**CREAK NOISE DURING BODY FLEX AND/OR TWIST - LEFT SIDE B PILLAR AND/OR LEFT SIDE ROCKER PANEL - BUILT ON 17-JAN-2017 AND THROUGH 15-MAY-2017**

**TSB 17-0059**

2017 Escape

Figure 1 - Article 17-0059

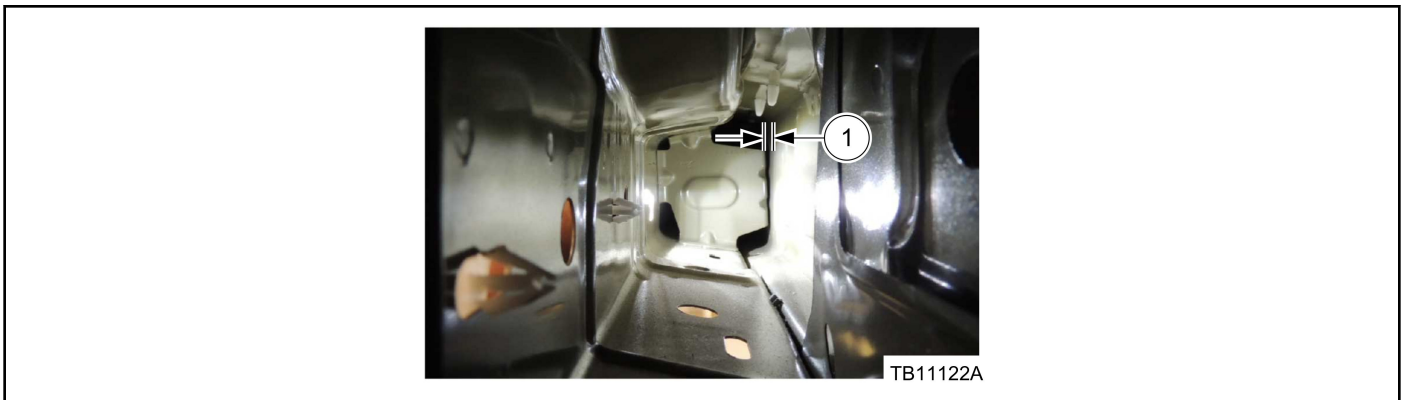
Some 2017 Escape vehicles built on 17-Jan-2017 and through 15-May-2017 may exhibit a creak noise during body flex and/or twist coming from the left side lower B-pillar and/or rocker panel. This may be due to a lack of rocker panel bracket to inner rocker panel clearance.

1. Drive the vehicle over uneven, rough roads and/or twist body structure by performing turns. Does the vehicle exhibit a creak noise from the left side rocker panel and/or lower B-pillar area?
  - a. Yes - proceed to Step 2.
  - b. No - this article does not apply. Refer to Workshop Manual (WSM), Section 100-04 for normal diagnostics.
2. Remove the left rear wheel and tire. Refer to WSM, Section 204-04.
3. Remove one plastic push pin from the left rear fender splash shield and position the fender splash shield aside. Remove the rubber body plug installed in the end of the rocker panel.
4. Using a prybar or equivalent tool of approximately 61 cm (24") long, create a 2-4 mm (0.079-0.157 inches) clearance between the rocker panel bracket and the rocker inner panel. (Figure 1)

5. Apply ValuGard™ Rust Inhibitor VG104, VG104A or equivalent to the inner surfaces of the rocker panel where interior corrosion coating damage may have occurred during the prying process. Refer to WSM, Section 501-25.
6. To install, reverse the removal procedure. Refer to WSM, Section 204-04.
